NEWS UPDATE 09

CLARIFICATIONS

1. Replies to Requests for Clarifications

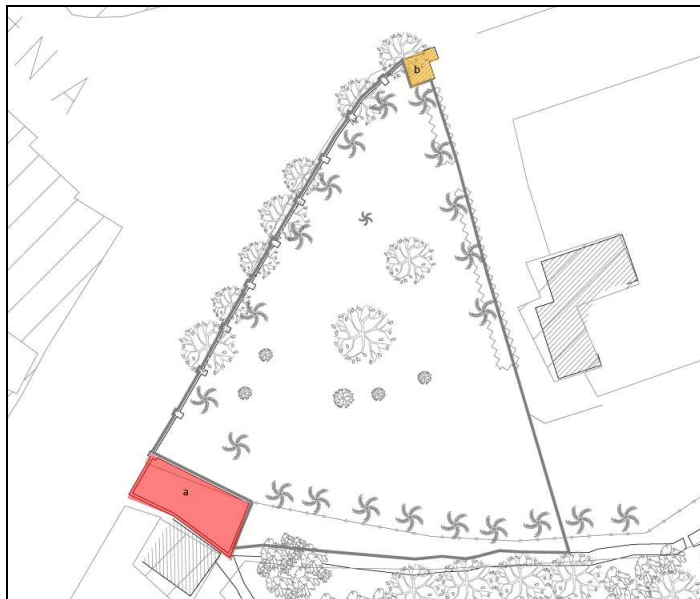
Q59. With reference to the structures marked as ‘A’ and ‘B’ on the image below, can the access (‘A’) be altered since it is infringing on the site? On the other hand, can the structure marked as ‘B’ be demolished?

A59. The structure marked as ‘A’ does not fall in the area under Heritage Malta’s guardianship. The structure marked as ‘B’ can be demolished.
